SUPPLEMENTARY MACHINE SERVICE BULLETIN 116-A

SUBJECT: Partial Supplement to Plate #12

DATE: November 18, 1931

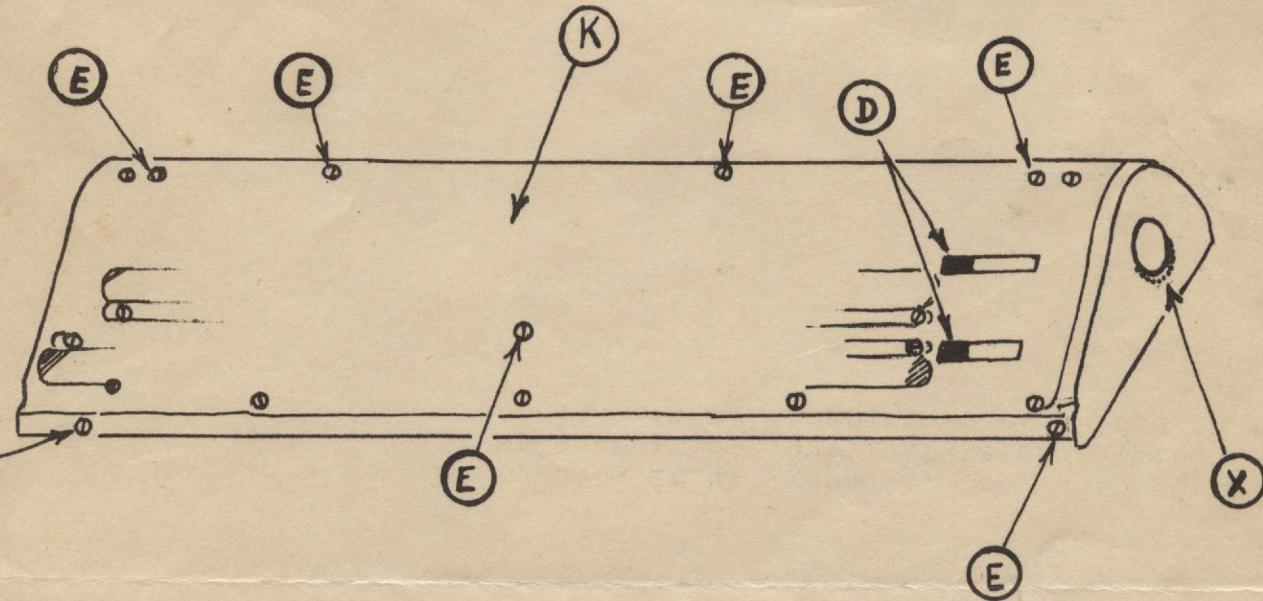
When it is necessary to remove the front carriage cover case complete as illustrated and explained on Plate 12, Figure 2, Operation 81, Machine Service Bulletin 116, elongate slots **D** to the left $1/16$ of an inch by filing with Kit Tool #21.

Remove screws **E** as shown on the revised illustration below. This eliminates removing all screws identified as **E** as shown on the original Plate 12, Figure 2, Operation 81, for the purpose of removing the front carriage cover case.

Before reassembling cover case **K** enlarge the lower half of the clearance hole for the clearout handle shaft $1/32$ of an inch by filing as shown by dotted line **X**. This eliminates a possible interference at this point when removing or reassembling the complete case.

As this change is incorporated in all recently manufactured machines do not file slots **D** or enlarge hole **X** until it is ascertained whether the cover case can be removed and reassembled as explained in this bulletin.
